Department of Planning, Housing and Infrastructure

Our ref: SSD-8445-PA-76

Subject: Tahmoor South Project (SSD-8445) LW S1A – S6A Extraction Plan – Amendment 1

Figure 1: Amendment 1 - Modified LW S3A Layout

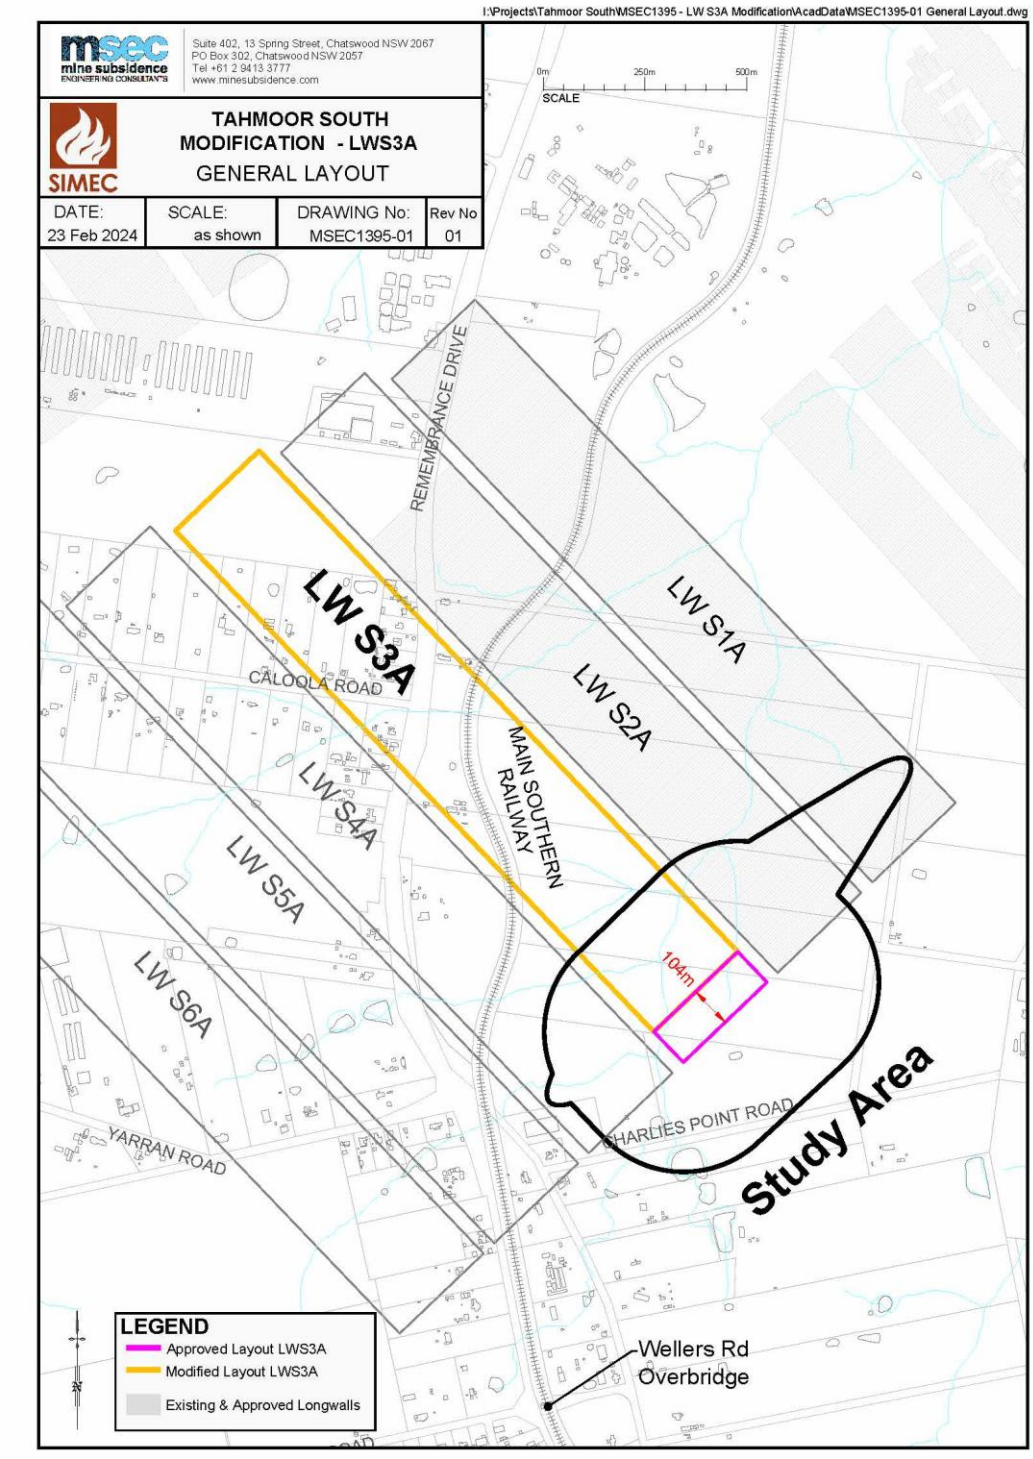
The Department notes that the amendment seeks to shorten the commencing end of LW S3A by 104 metres from the position approved in the LW S1A-S6A Extraction Plan. The modified layout of LW S3A is shown in **Figure 1**.

Accordingly, on behalf of the Planning Secretary, I approve Amendment 1 to the Tahmoor South LWS1A – S6A Extraction Plan to shorten the commencing end of LW S3A by 104 metres. If you wish to discuss the matter further, please contact Gabrielle Allan on 02 9585 6078.
